INDESIT company

Model type:
AVF129SKTE

Commercial code:
F042546

n4008f00: Thermic link wire removed on three-phase motor

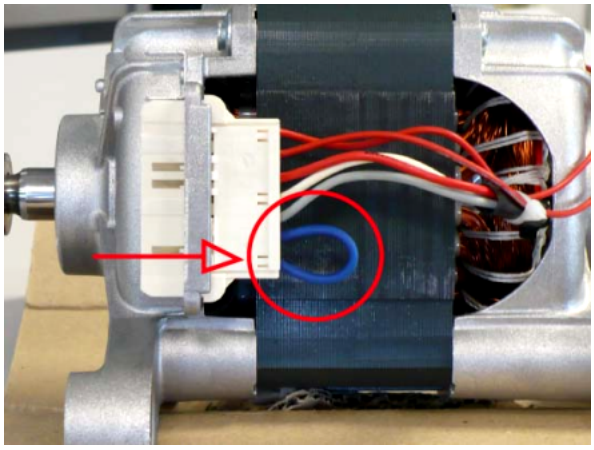
Attention!
When you assist the premodification models using the new motor code you MUST use the thermic link wire code C00265838.

The spare part warehouses will manage the premodification motor until the end of the stock, after they will be replaced with new ones and thermic link wire.

TRIPHASE P40 46 L – INOX TUB
C00265827 new motor without thermic link wire - C00116103 premodification motor with thermic link wire

TRIPHASE P40 46 L – PLASTIC TUB
C00265826 new motor without thermic link wire - C00142390 premodification motor with thermic link wire

TRIPHASE P50 52 L
C00265829 new motor without thermic link wire - C00142205 premodification motor with thermic link wire

TRIPHASE P32 46 L TOP LOADING
C00265832 new motor without thermic link wire - C00262375 premodification motor with thermic link wire

TRIPHASE P40 46 L TOP LOADING
C00265834 nuovo new motor without thermic link wire - C00112739 premodification motor with thermic link wire

In the attached image you can see the fixing of thermic link wire in the motor therminal box.
